Design Review Board Meeting
Tuesday, May 28, 2024 - 5:30 PM
AGENDA

Design Review Board
Tuesday, May 14, 2024 - 5:00 PM
MINUTES

6. Application # 4-18-1 Certificate of Appropriateness 412 Buena Vista Drive ; Solar Panels

7. Application 4-11-2 Certificate of Appropriateness 921 W. Coshocton Street; Sign Permit (ACE Hardware)

DOUBLE-FACE ALUMINUM EXTRUSION CABINET LED INTERNALLY ILLUMINATED
PAINTED RED WITH SEMI-GLOSS FINISH
FLAT LEXAN FACE WITH RED VINYL APPLIED FIRST SURFACE
DISCONNECT SWITCH
Test font: Berlin Sans FB Demi
BRICK BASE BY OTHERS

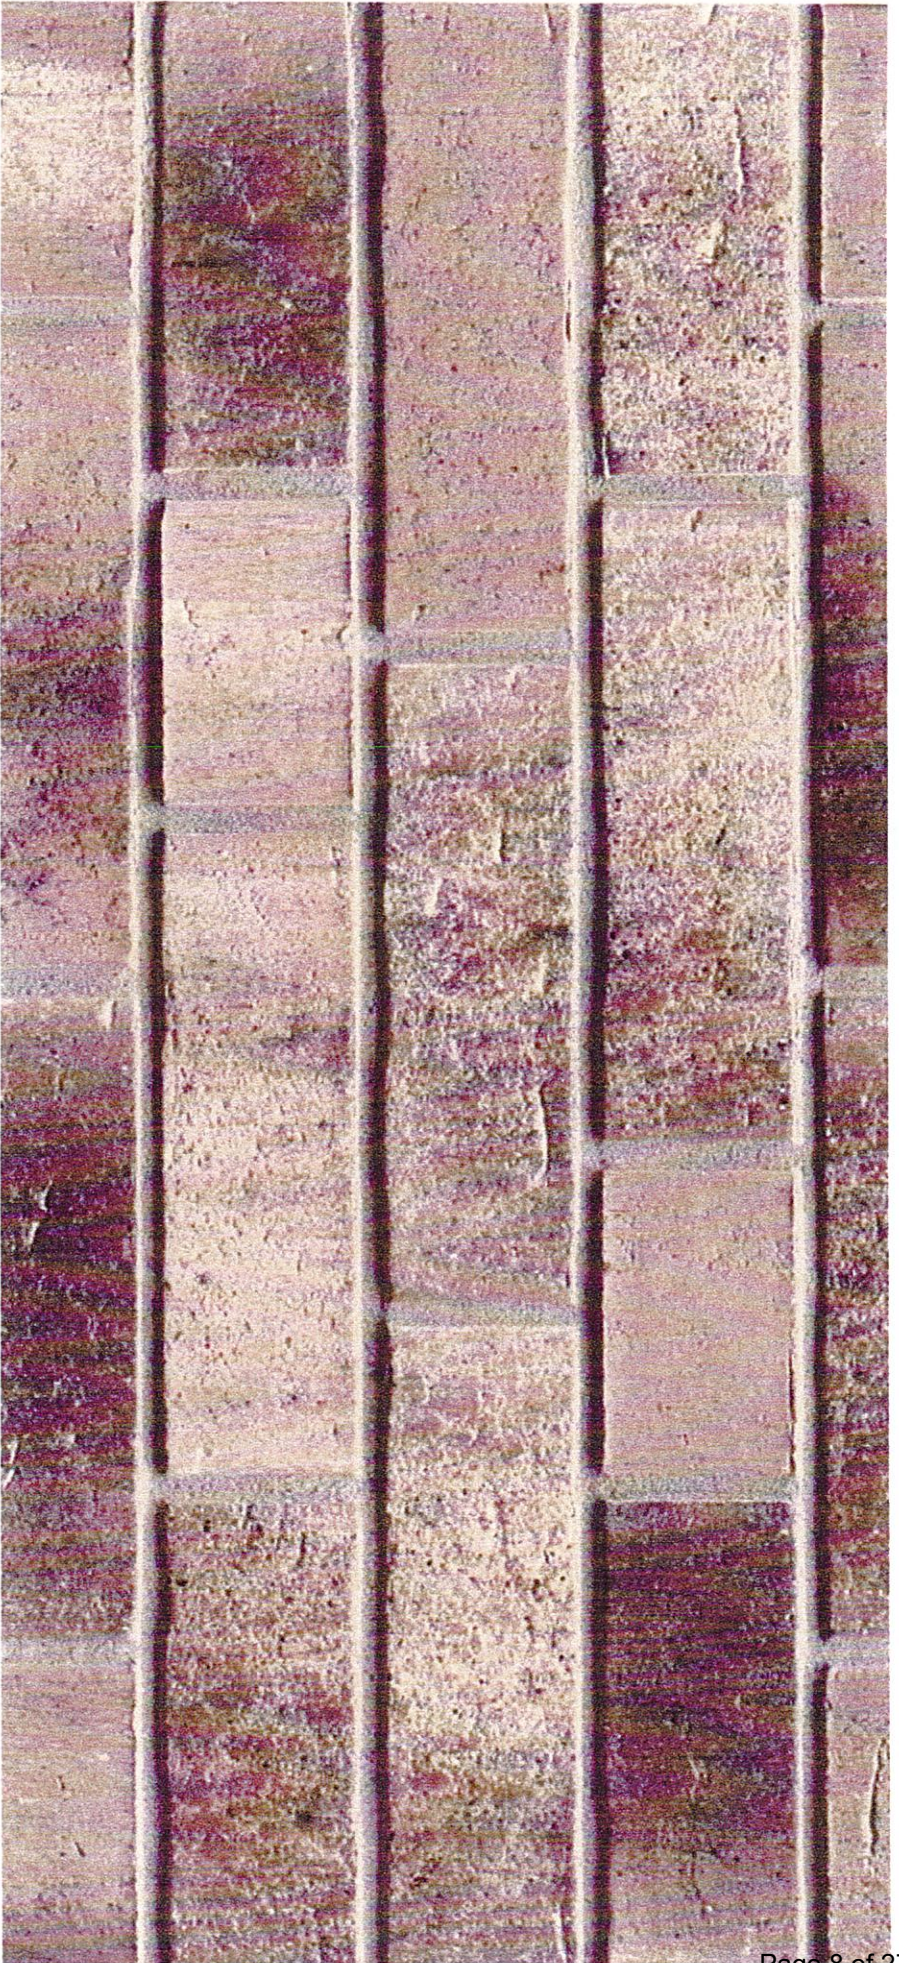
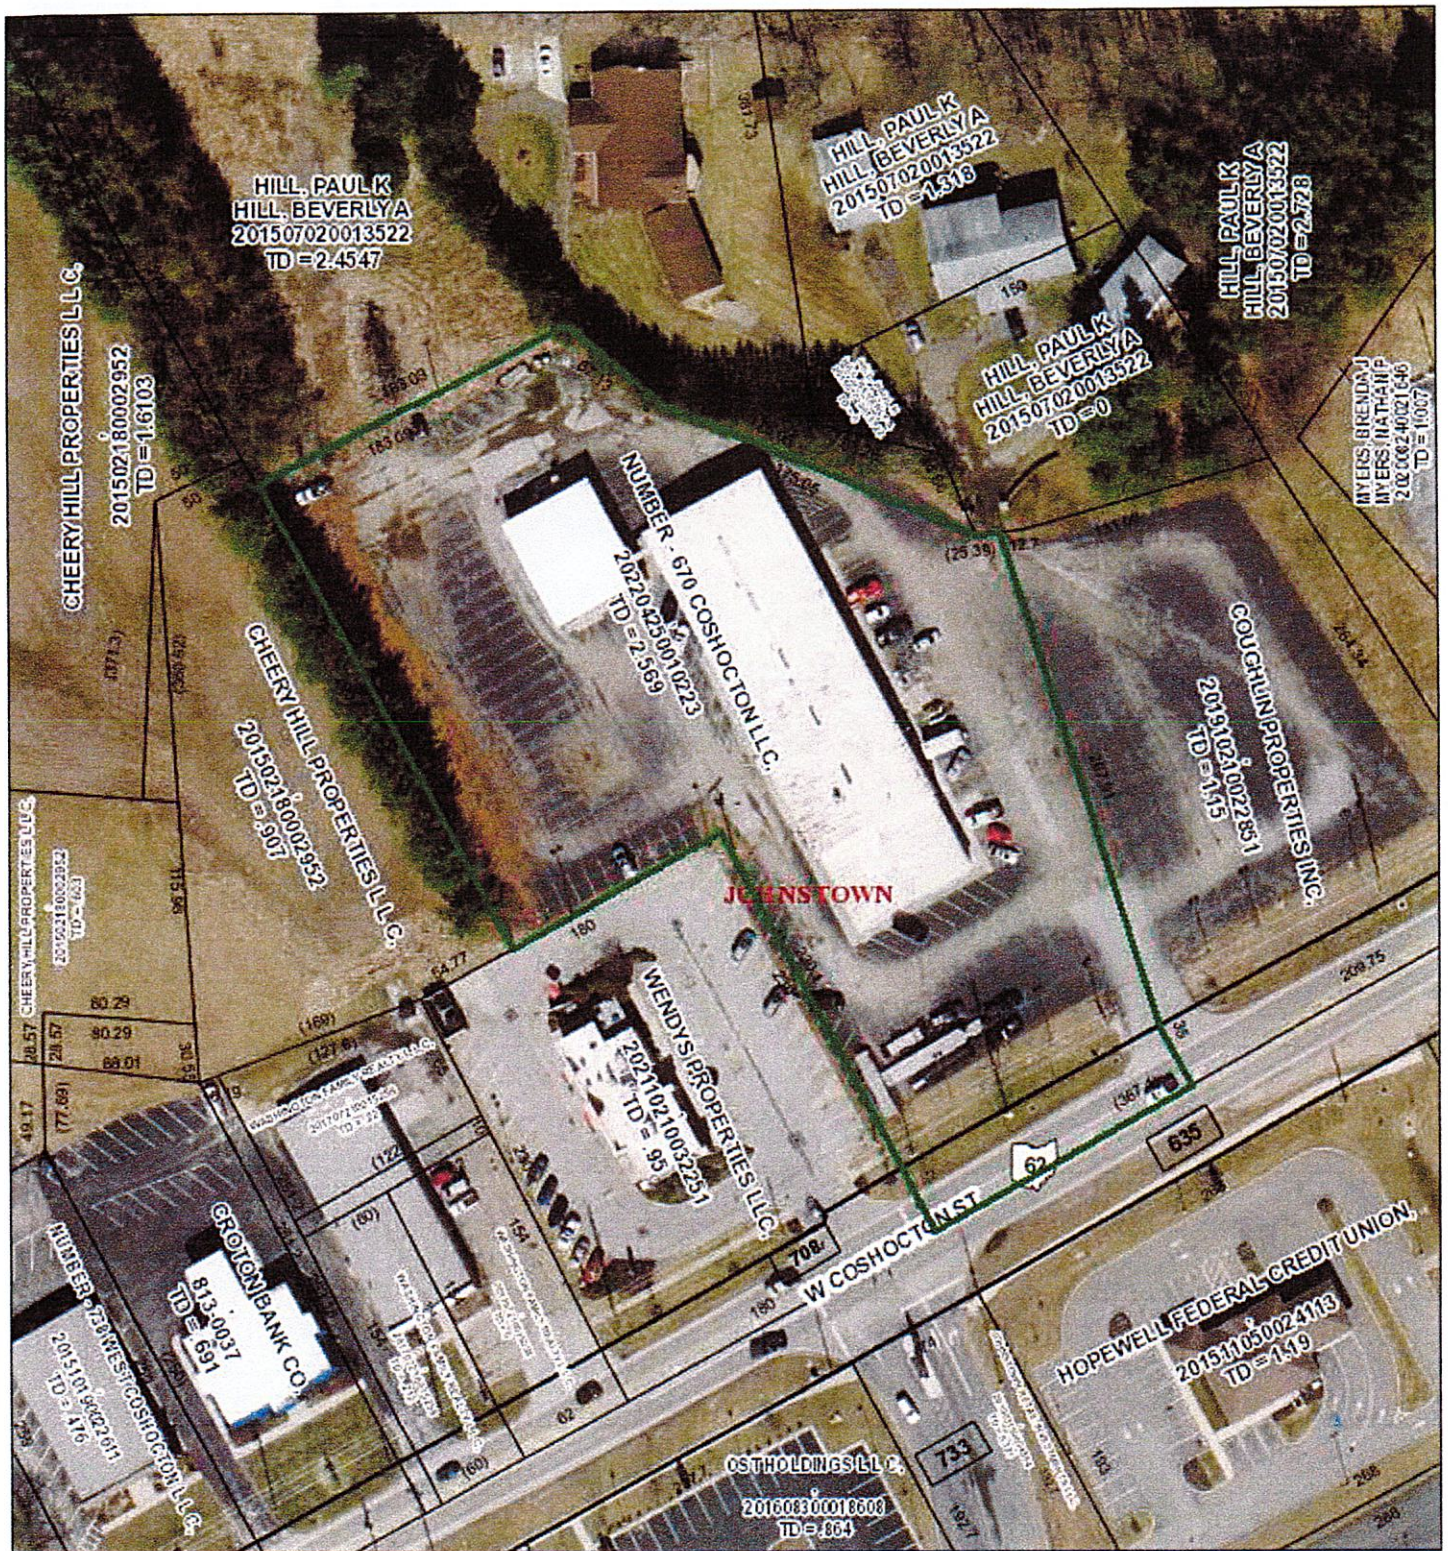
Sean Staneart reviewed the application and sign dimensions and stated that they are in compliance. Steve Moore with Moore Signs and ACE Hardware owner Mike Dwyer were present for the application. Mr. Moore reviewed the sign specifications and design presented in the packet. The Board was in favor of the sign as presented, there was discussion on exterior lighting for the sign and conditional approval of lighting with this COA application.

- Referenced the zoning code requiring a minimum letter depth of one inch. It was noted that this sign is two inches.

Conditions for approval:

1. Sign to be up lit from the canopy
2. Light to "wash" the sign, not spotlight, and not to extend past the tower roof line
3. Dimmable light
4. 5,000 Kelvin
4. Fixture minimum of two, maximum of three, to be concealed

ELEVATION
WITH MODULES

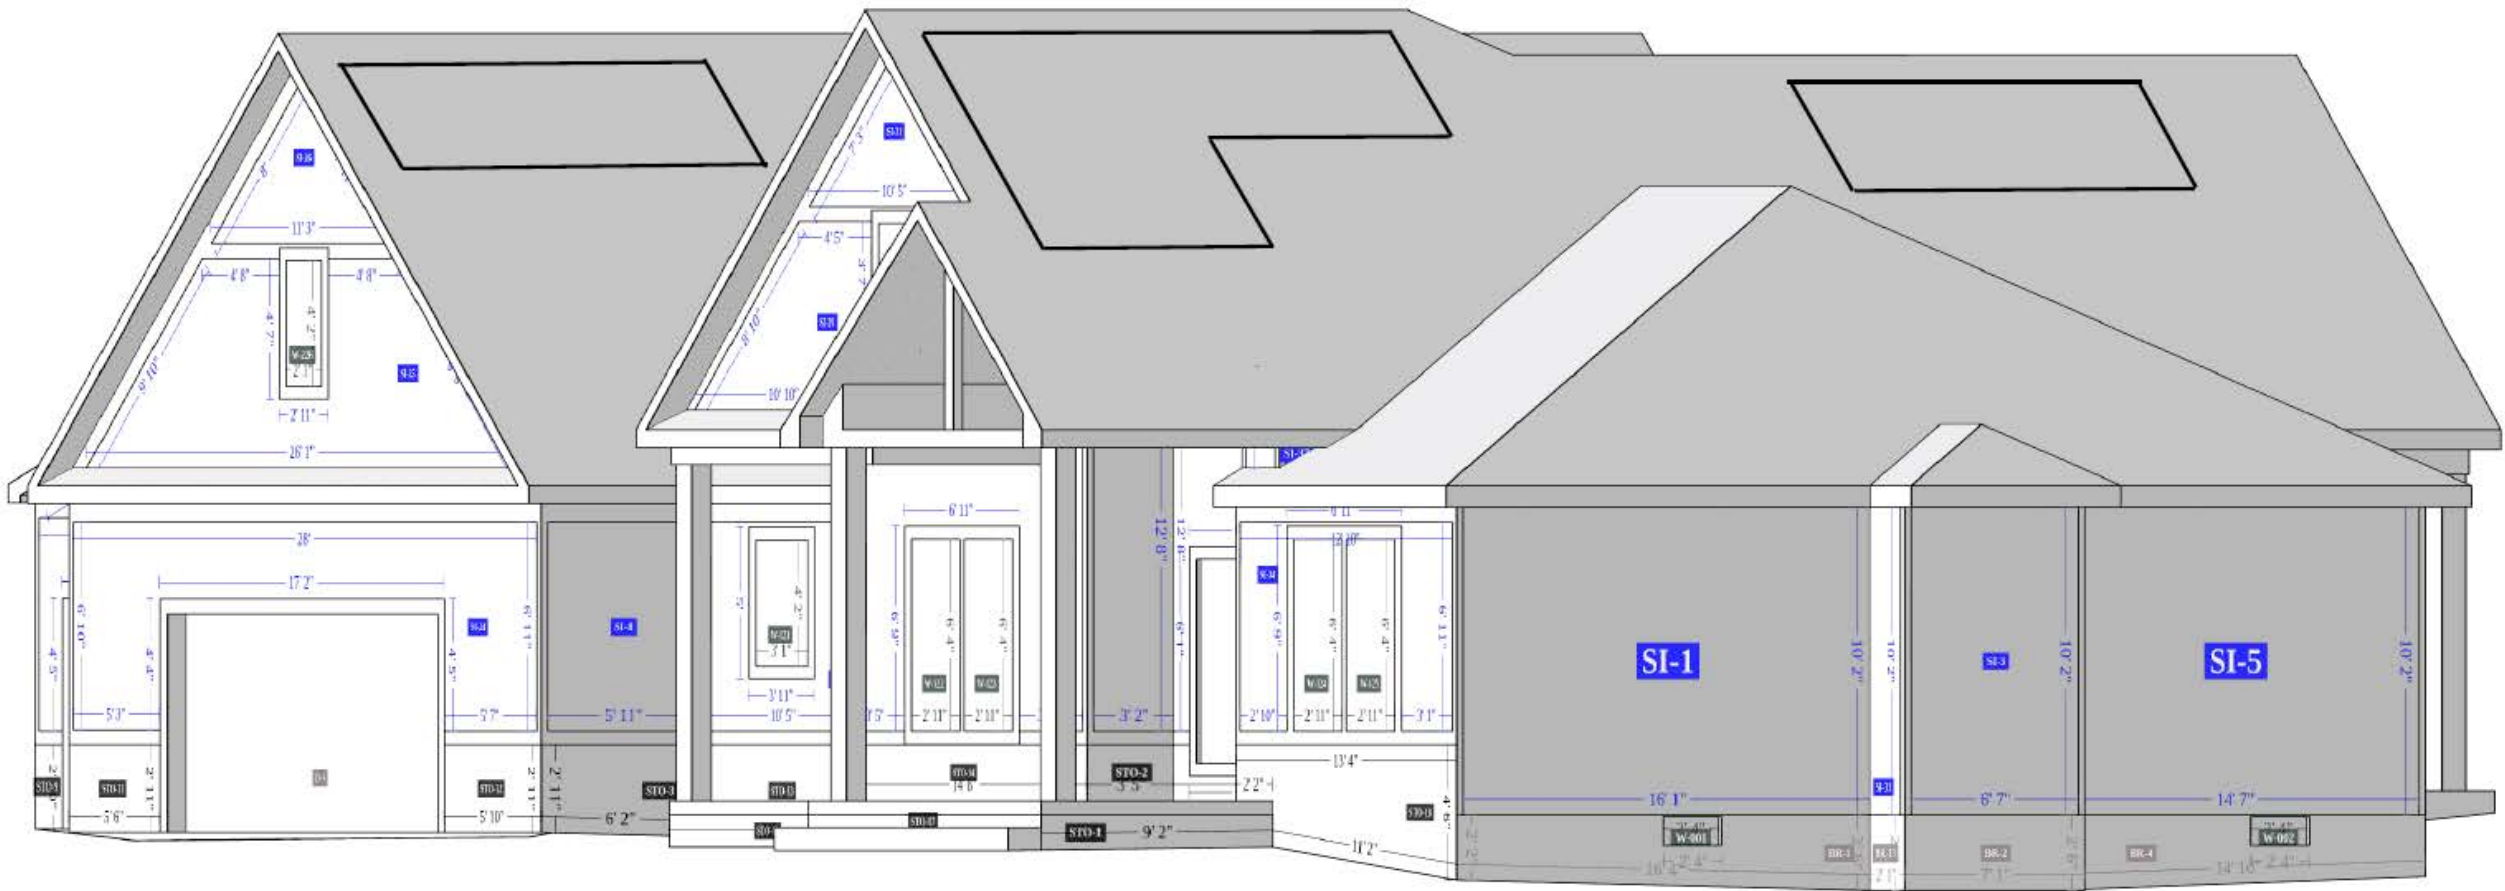
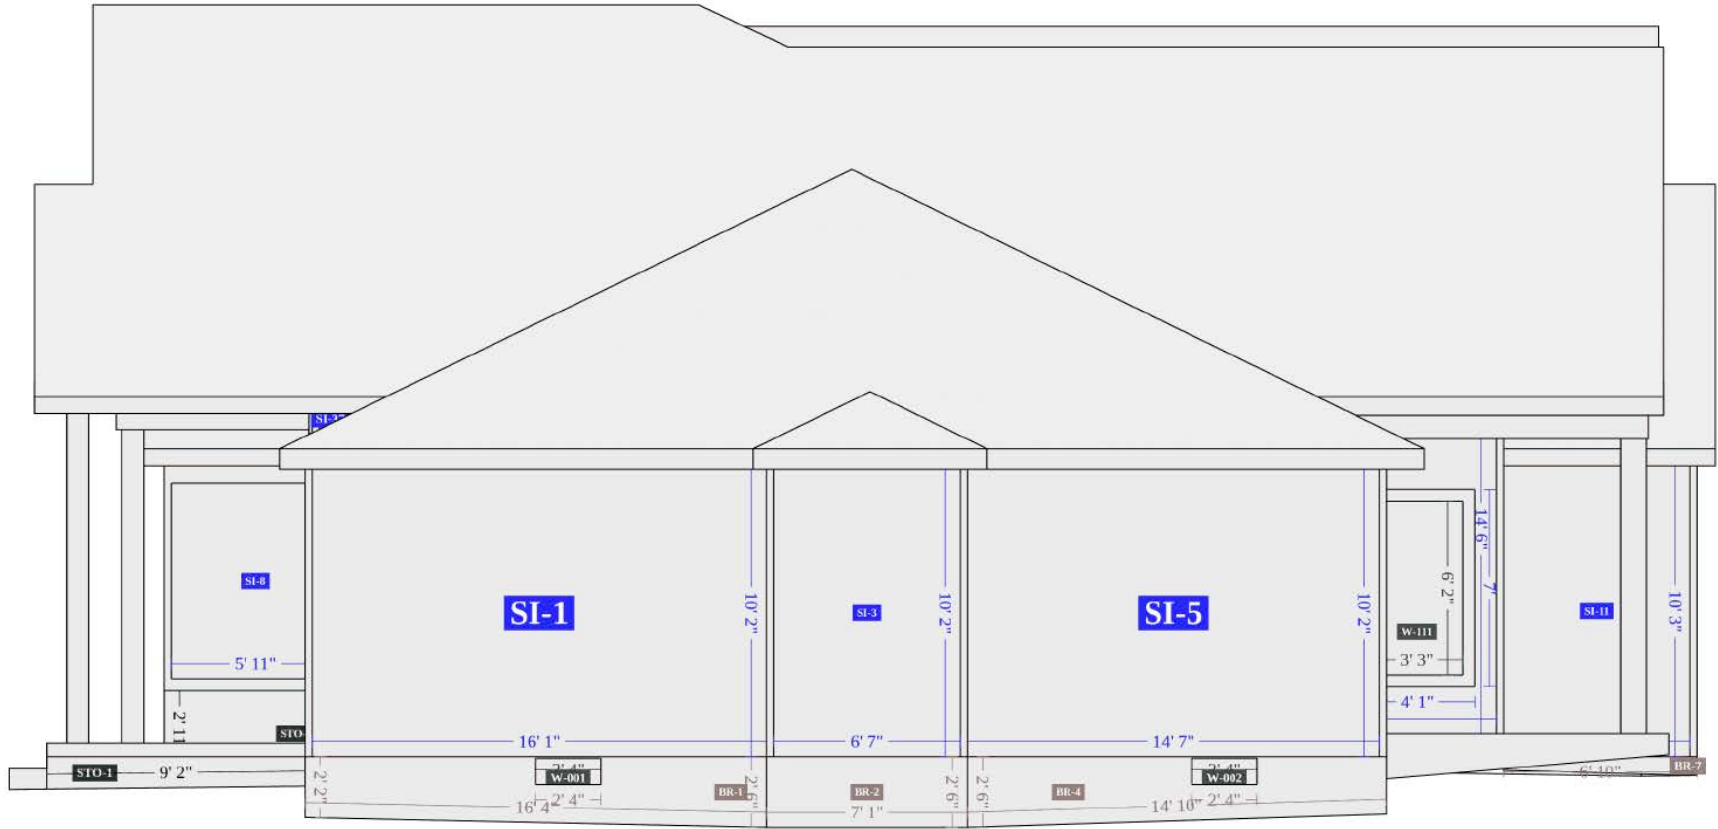
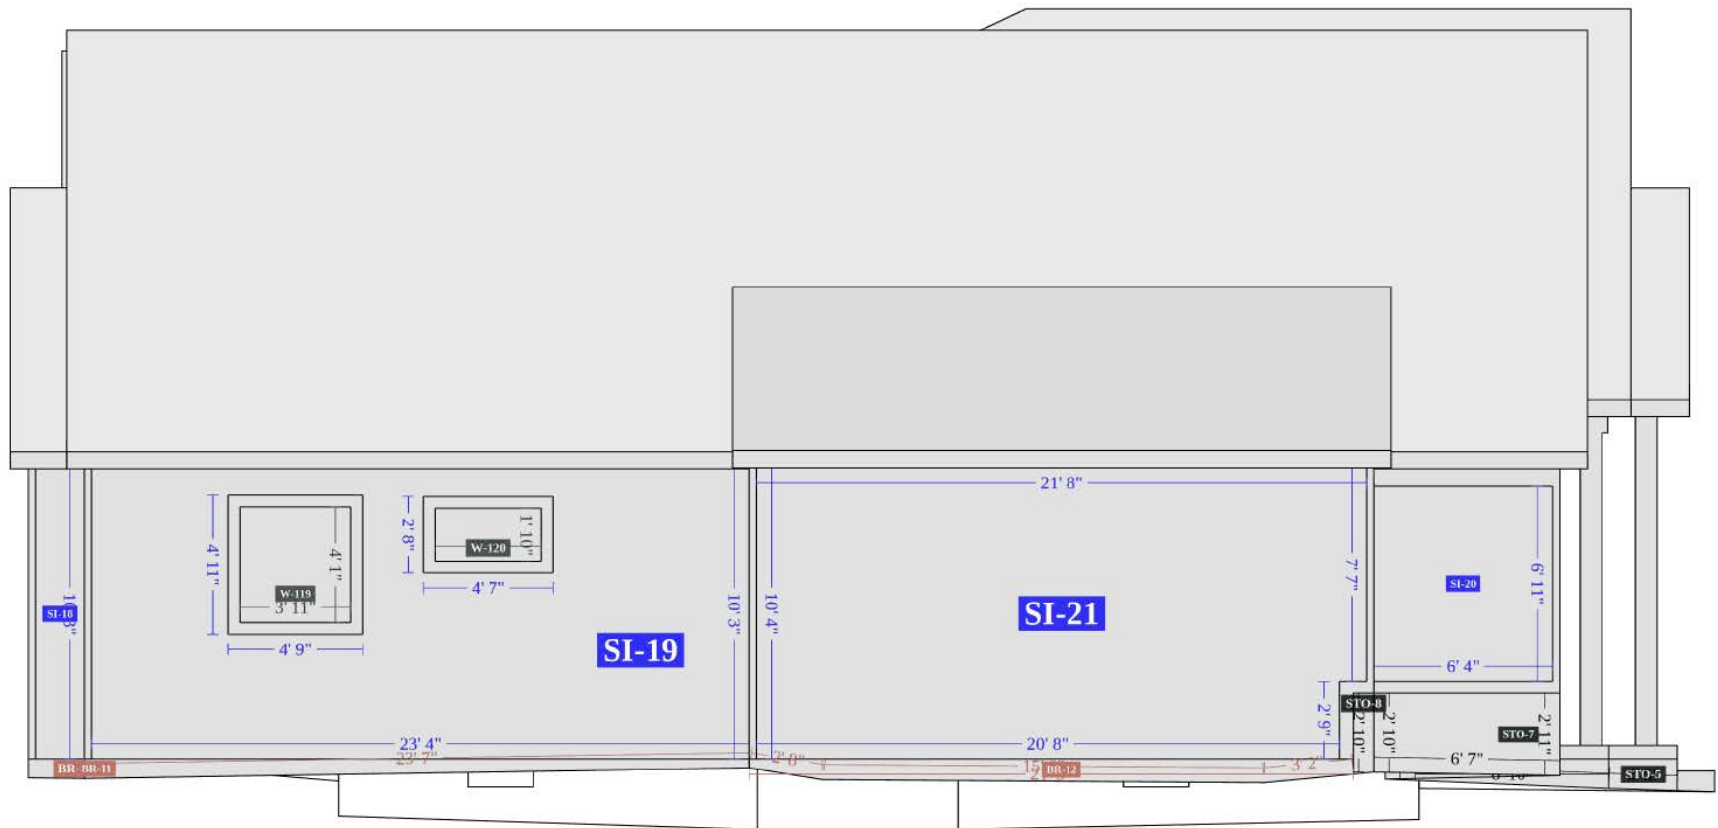
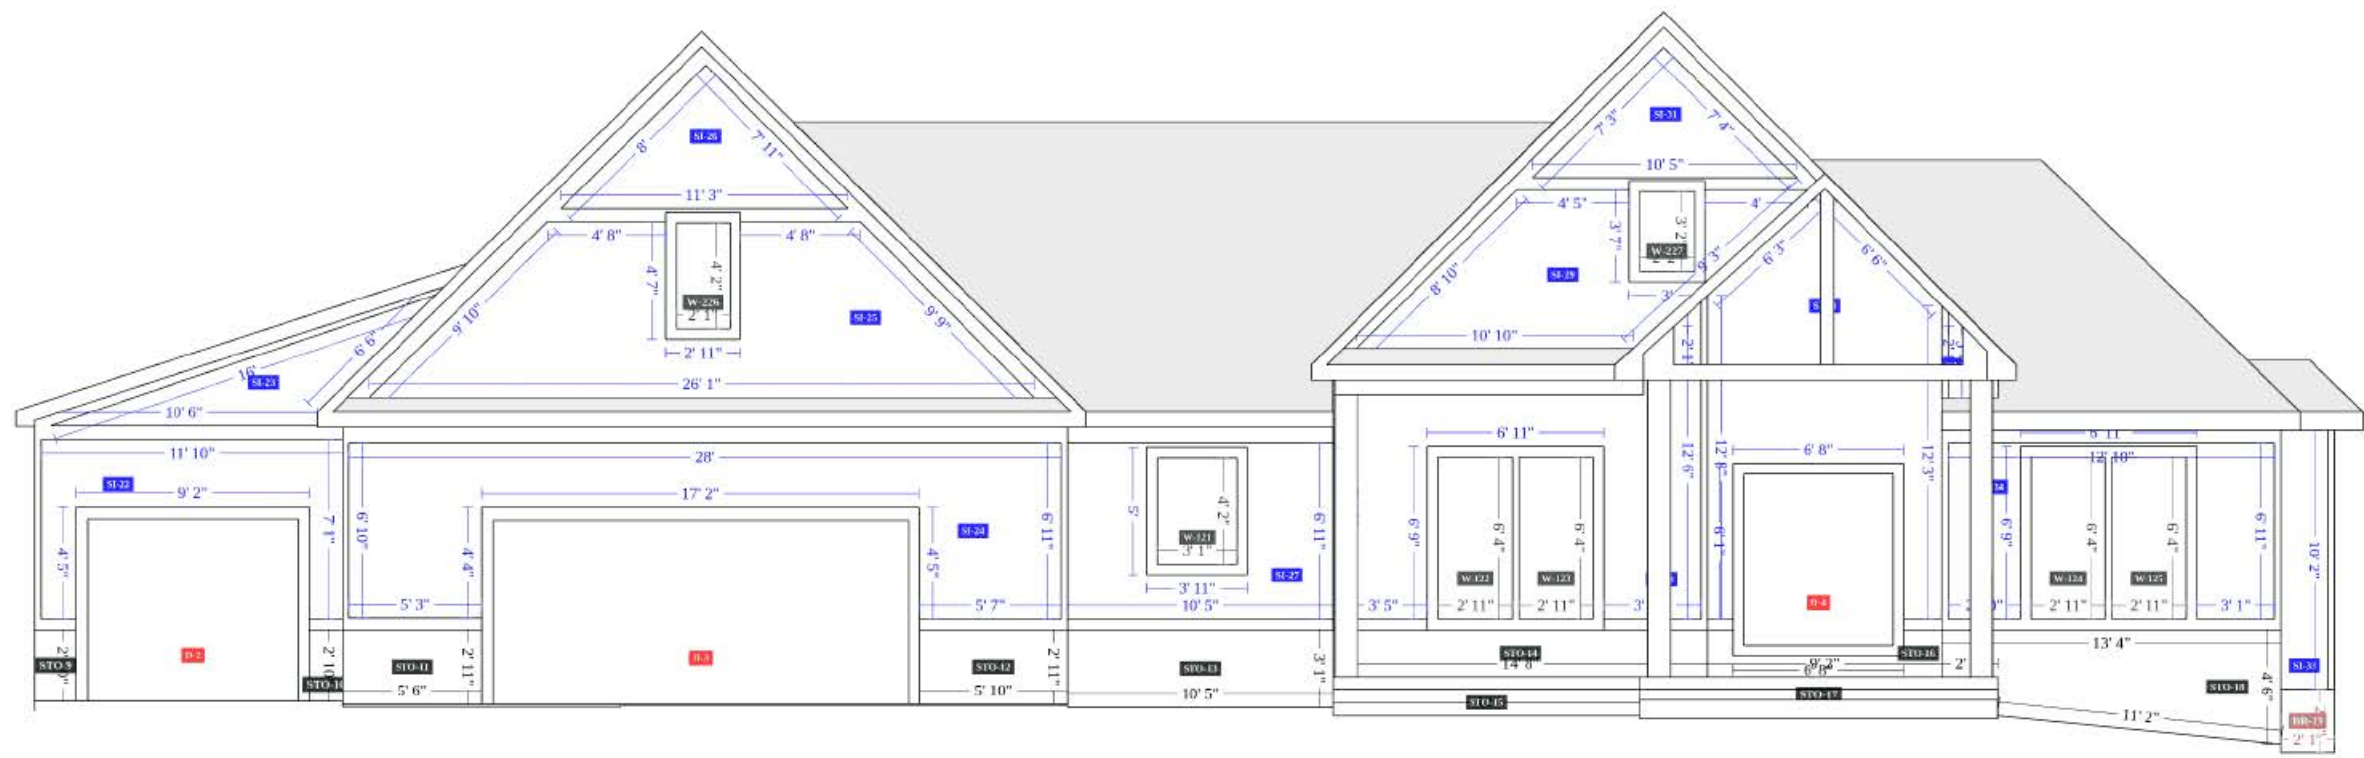
Logan Miller, a representative for the applicant was present and said he could speak generally on the project because their sales are exclusive with one manufacturer, but this specific project was not one of his sales therefore he is not a lead on it. An overhead view of the site plan and system diagrams were provided with the application. Board Chair Heather Green said that at this point she does not think they can fully review what they are seeing and would recommend tabling this application. She informed Mr. Miller that they need to be able to see what this will look like because this is a body that reviews for design. The board requested that the applicant return with visuals from all sides, elevations and sight line views.

ACTION: Heather Green moved to table application #4-18-1, with the stipulations that they need to see elevations and sight line views; Andrew Hale seconded and the vote was as follows:
AYES: Heather Green, Franz Stein, Craig Bohning, Candice Evans, Andrew Hale
NOES: None
ABSTAIN: None
